## Descriptive Report to Accompany Hydrographic Survey H12143

Project OPR-O351-FA-09

Upper Glacier Bay

## **Revisions and Corrections Compiled During Office Processing and Certification**

**Figure 2: Crossline and main scheme differences (grey indicates agreement, warm colors indicate XLs shallower than mainscheme and cool colors indicate XLs deeper than mainscheme).**

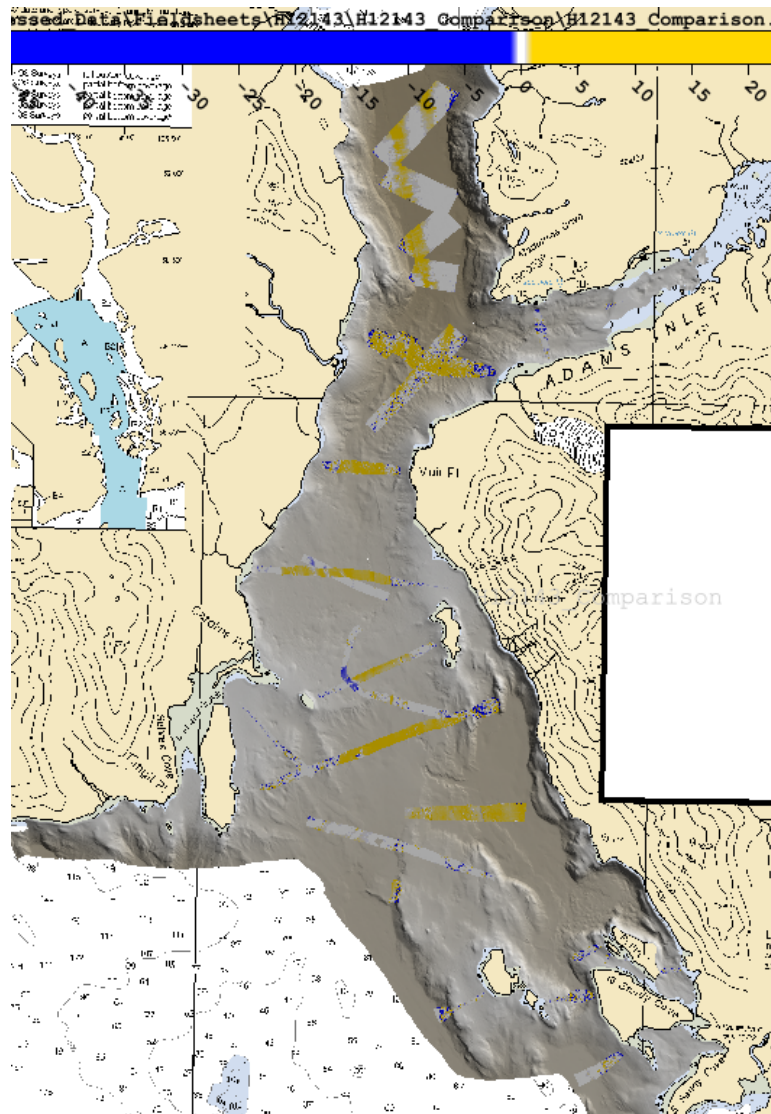
Surface differencing in CARIS Bathymetry DataBase was used to assess crossline agreement with mainscheme lines. Figure 2 shows a visual depiction of the differences spatially. The area located around the outlet of Adams Inlet shows differences which are attributed to sound velocity artifacts in the MBES data caused by inflow of water coming from Adams Inlet and a freshwater source on the western shore.<sup>1</sup>

<sup>1</sup> Concur. Higher differences are expected in areas of freshwater outflow. The data has been inspected and deemed adequate for charting.

Figure 3: Junction between H12142, H12143 and H12144.

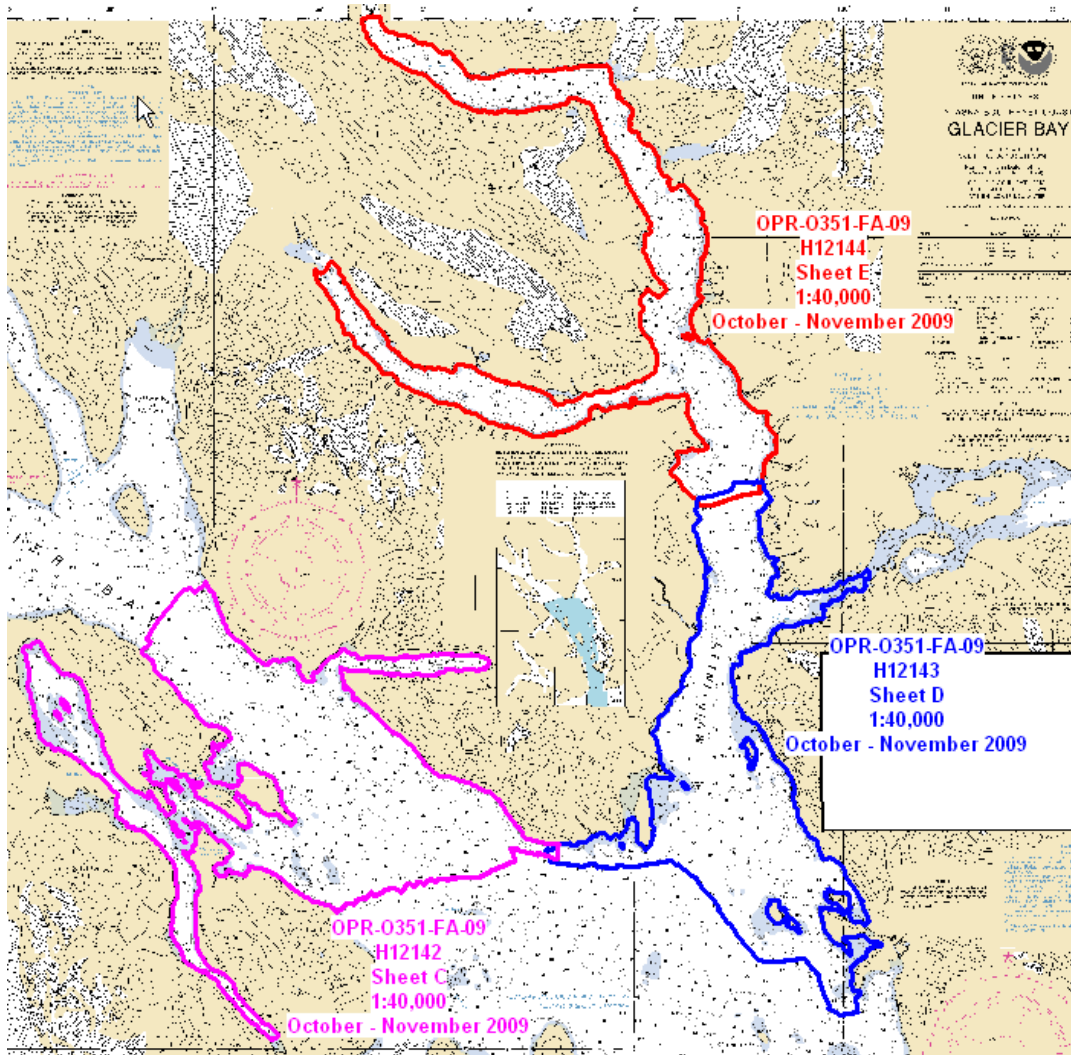
Survey H12143 junctions with H12142 (Sheet C) and H12144 (Sheet E) of the same project.<sup>2</sup> Both surveys were completed October-November 2009. The area of overlap between the sheets was reviewed in CARIS Subset Editor for consistency and data were found to be in agreement within 1-2 meters in depths shoaler than 100 meters. The greatest differences, 3-5 meters, occur in depths of 300 meters where the Reson 7111 data has sound velocity and bottom detection issues (see section B.4 of this report). The sheet limits and areas of overlap are shown in Figure 3.<sup>3</sup>

<sup>2</sup> A common junction was made with H12144 which has already been compiled. A common coverage junction was made with H12142. A common junction with the bathymetry and features will be made when that survey is compiled.

<sup>3</sup> Concur with clarification. The SAR reviewer noted depth differences of up to 9 m in the Reson 7111 data. The differences due to bottom detection and sound speed errors in 300m of water are not navigationally significant and therefore acceptable.

Figure 4: Holiday views in CARIS Subset editor (58°42'42"N, 135°58'55"W).

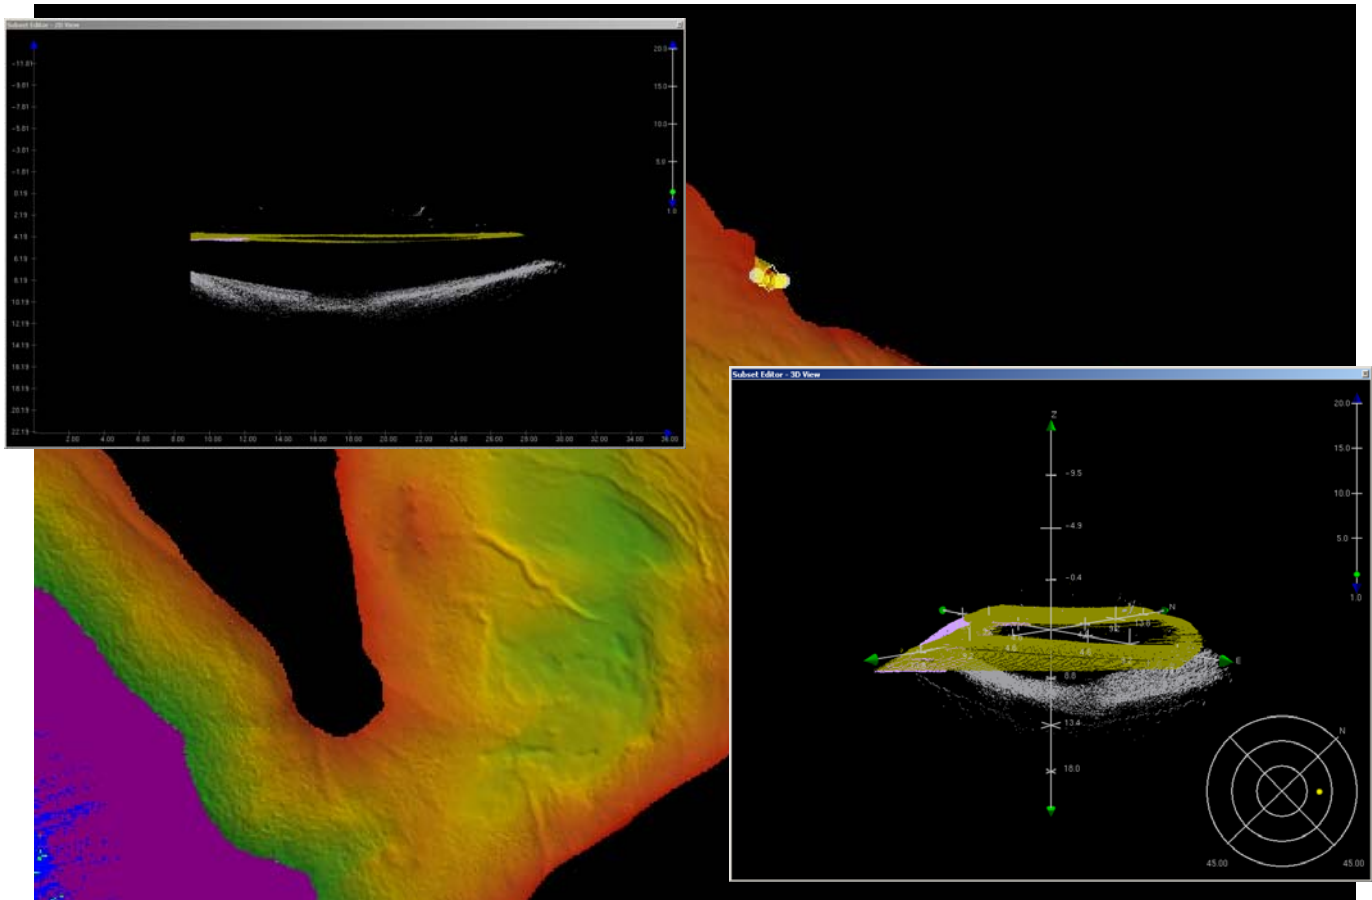
For holidays larger than three surface nodes, the corresponding multibeam pseudo side scan data were examined in CARIS HIPS and no navigationally significant items were found; additionally, the least depths are represented. One large holiday was found during analysis after leaving the working grounds. Figure 4 below shows the location and subset views of this holiday located in South Sandy Cove, in the nearshore area approximately 40 meters from a charted rock.<sup>4</sup>

<sup>4</sup> Due to the fact the holiday is within 40m of a charted rock, it was determined that it was not navigationally significant at chart scale.

Figure 5: IHO Order 1 Pass (green) or Fail (red).

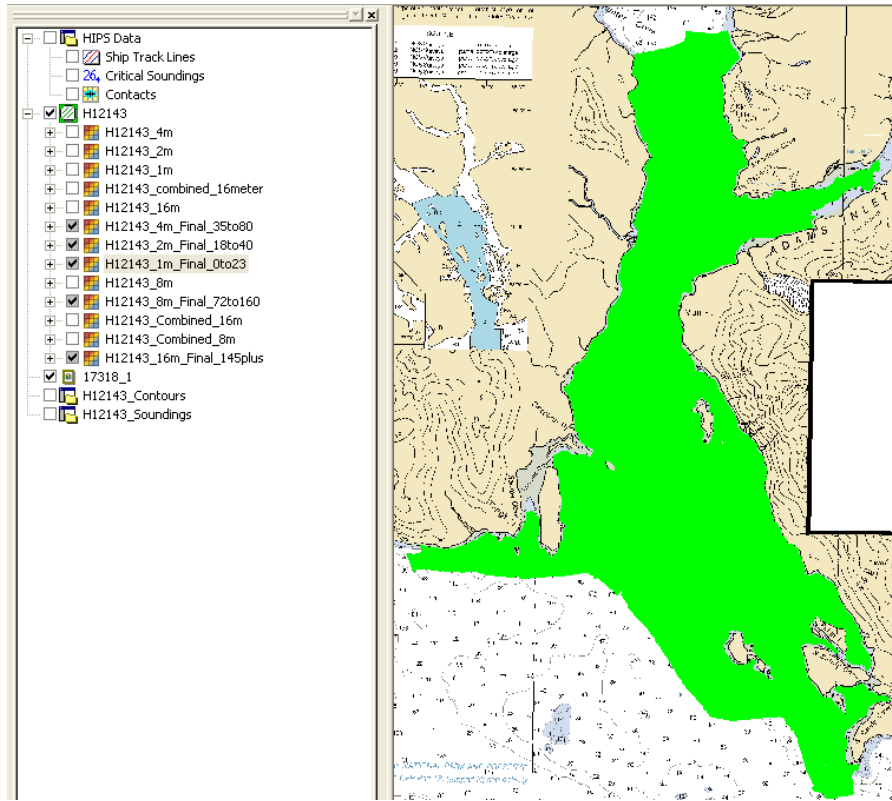
All data meet the accuracy specifications specified by the HSSDM.<sup>10</sup> Figure 5 shows vertical IHO Order I child layers shown on finalized layers for all depth ranges. Green indicates that the node uncertainty is less than the allowable vertical IHO Order I tolerance for the depth of the node. Red indicates that the node uncertainty is greater than the allowable vertical IHO Order I tolerance for the depth of the node.

<sup>10</sup> Concur.

**Figure 6: Location and Subset of effected data showing outer beams compared to nadir (58°44'55"N, 136°06'22"W).**

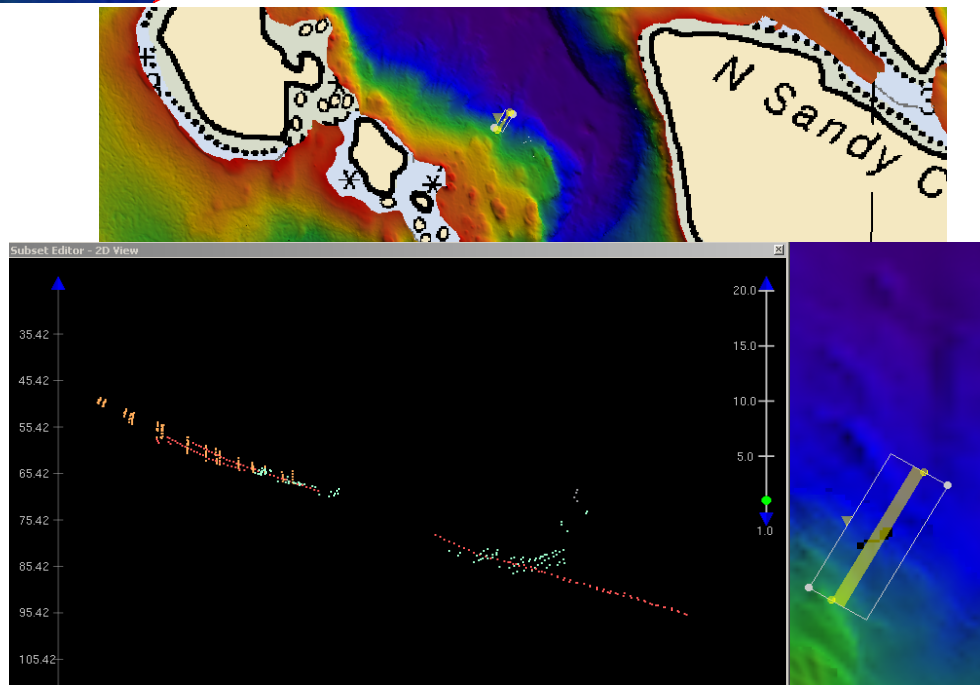
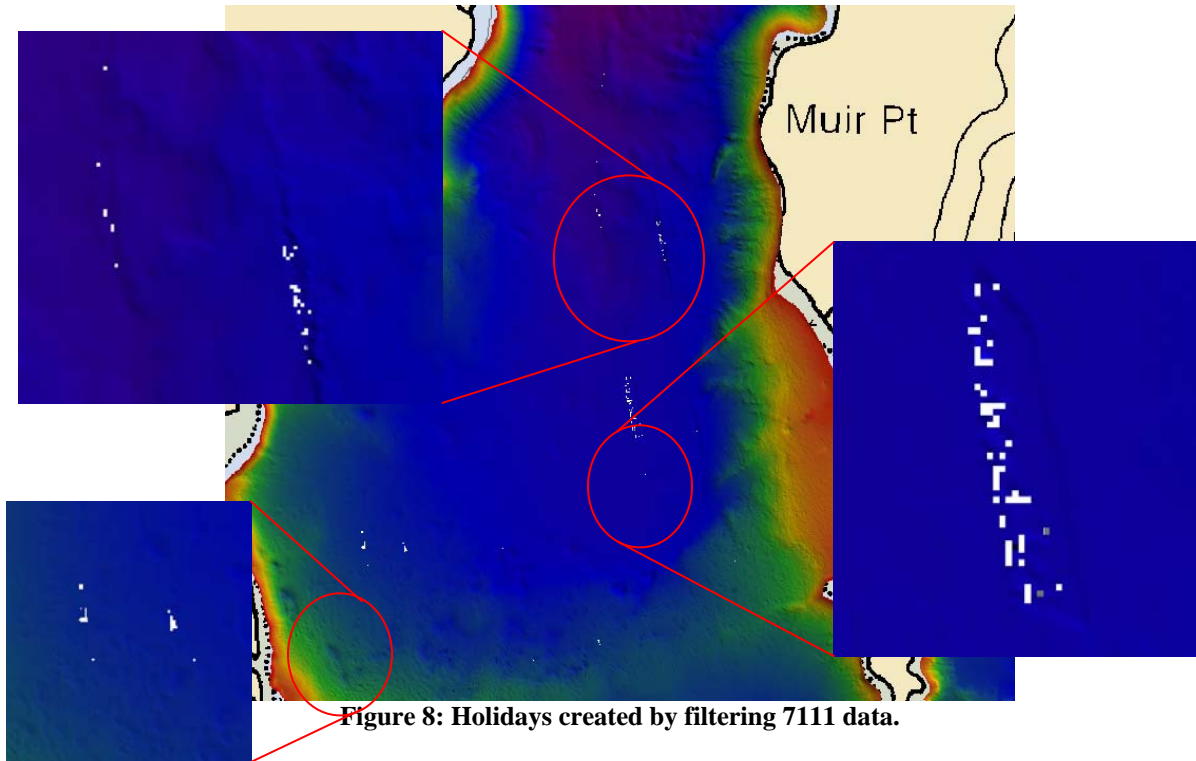
During post processing of H12143, various data quality issues with Reson 7111 data were identified, the most significant of which are apparent in the outer beams. These issues ultimately lead to a new bottom detection algorithm to be implemented in the Reson processing software. The figures below depict cases in which outer beams from the Reson 7111 do not align with adjacent lines. A 60/60-degree filter was applied to all Reson 7111 lines except on lines near shore for which the upslope beams were crucial for defining the slope. For near shore lines only the down-slope beams were filtered to 60 degrees.

Where filtering resulted in holidays, the hydrographer reviewed the data in CARIS Subset editor and accepted data after reviewing the quality of the soundings. The figures shown on the following page depict areas where holidays were created and the hydrographer determined that soundings should not be accepted.<sup>14</sup>

<sup>14</sup> Concur. The holidays are located in deep water and are not navigationally significant. The holidays were not preserved in the HCell coverage.
